# CONTRACT DRAWINGS FOR CONSTRUCTION OF COTTONWOOD CREEK RECLAMATION - PHASE 1 OCTOBER, 2003

### RECORD DRAWING

### SHEETS ADDED DURING CONSTRUCTION

**CHECK STRUCTURE PLAN DETAIL**

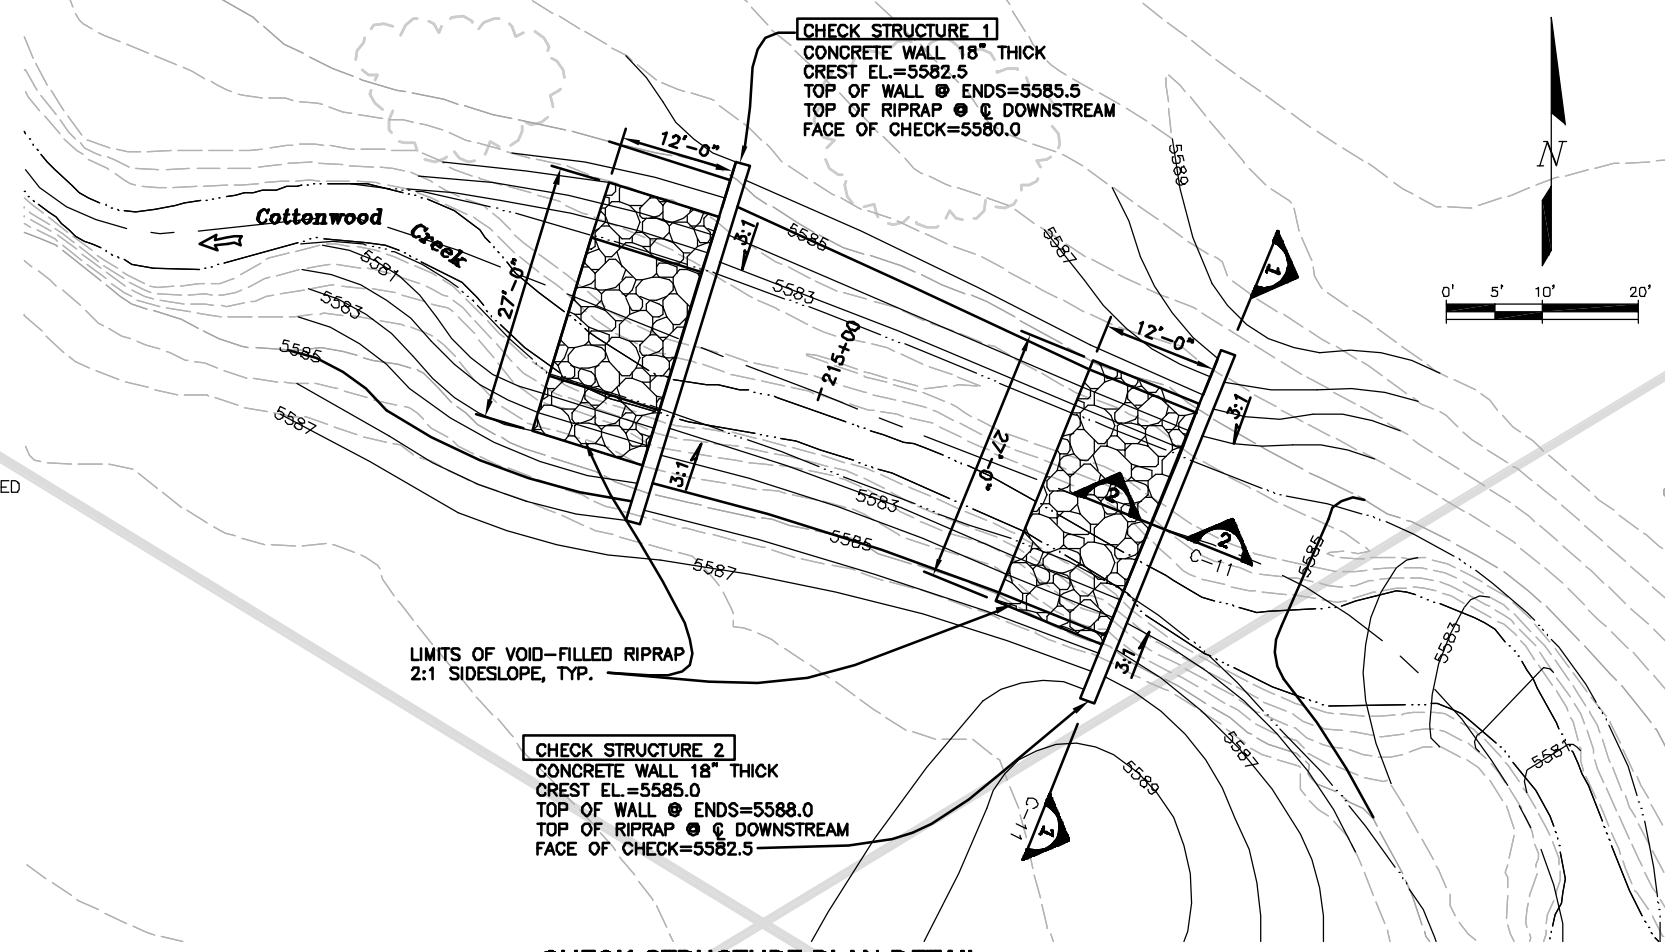
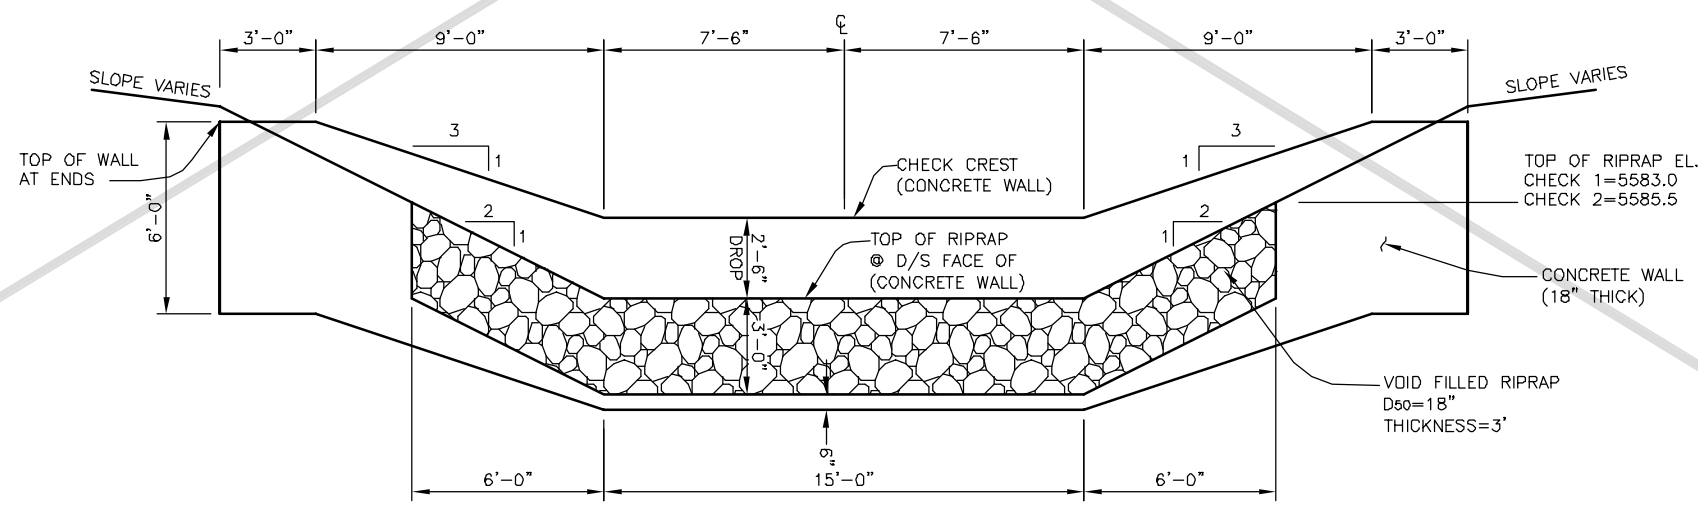
**1** CHECK STRUCTURES ELIMINATED.

CIVIL  
**GRADING PLAN  
DISPOSAL AREAS NO. 1**

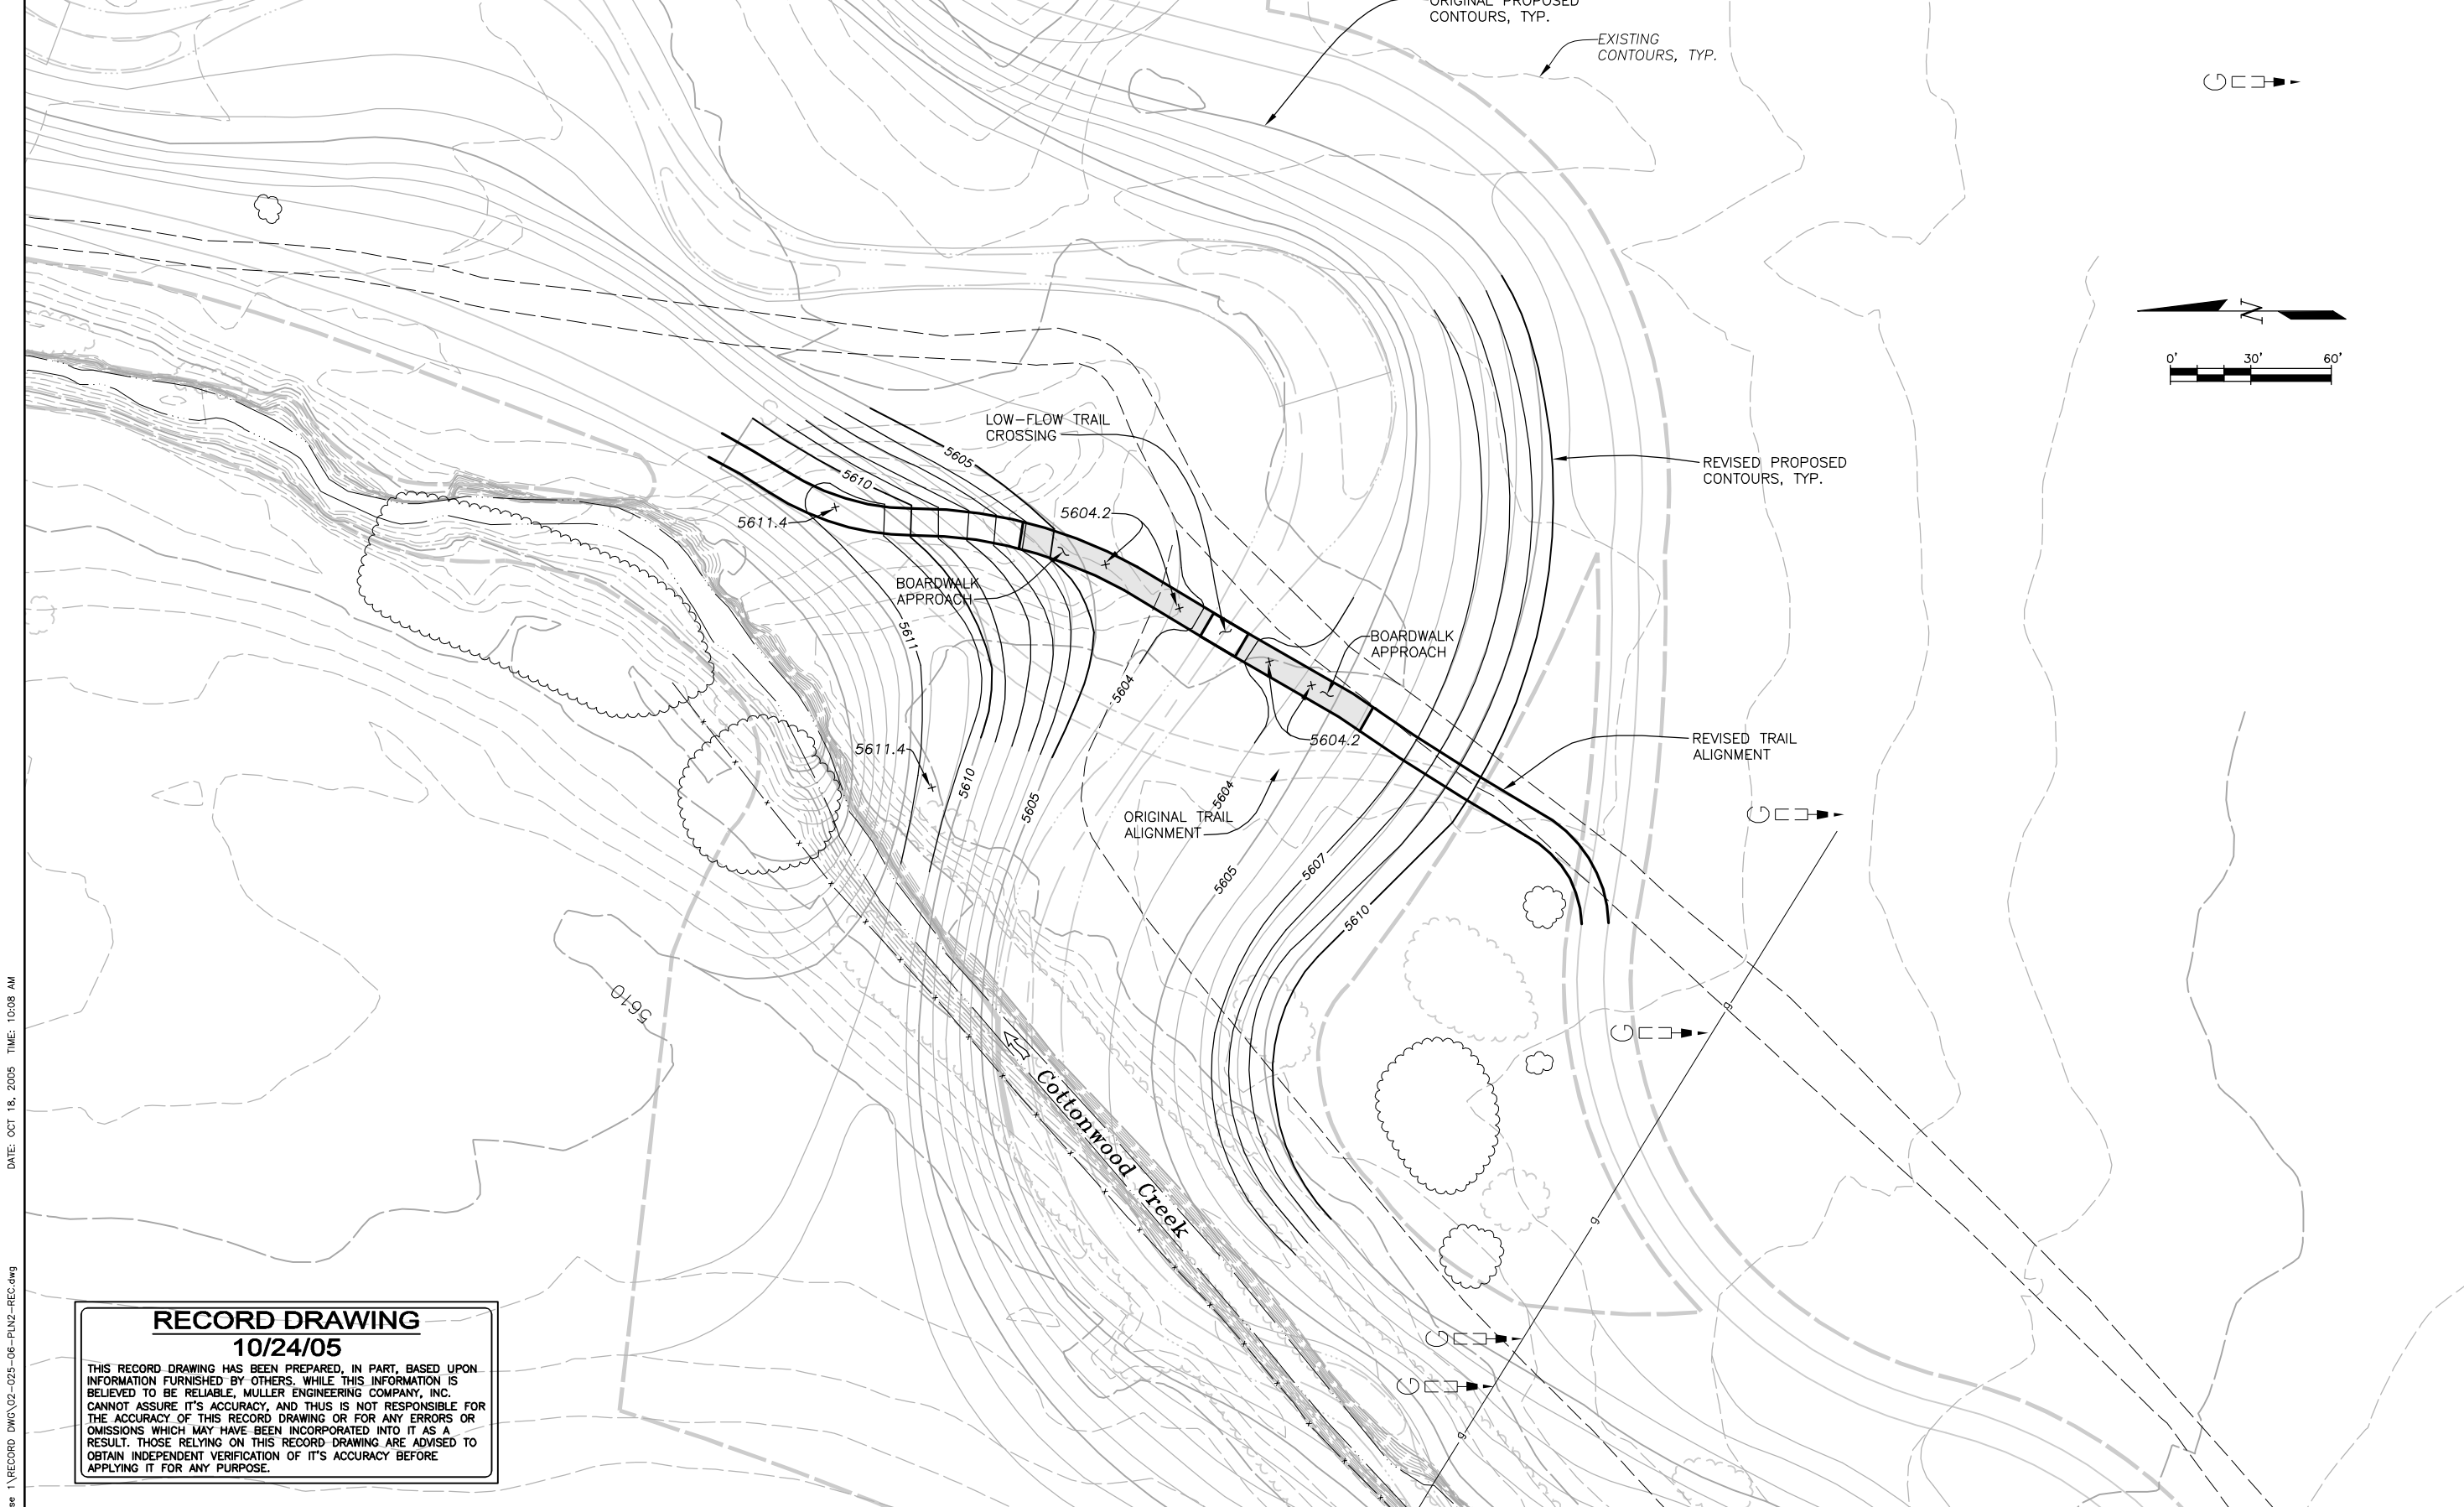
NO FILL PLACED IN DISPOSAL AREA NO. 3

FILL PLACED UP TO AS CONSTRUCTED ELEVATION SHOWN ON DWG. D-1
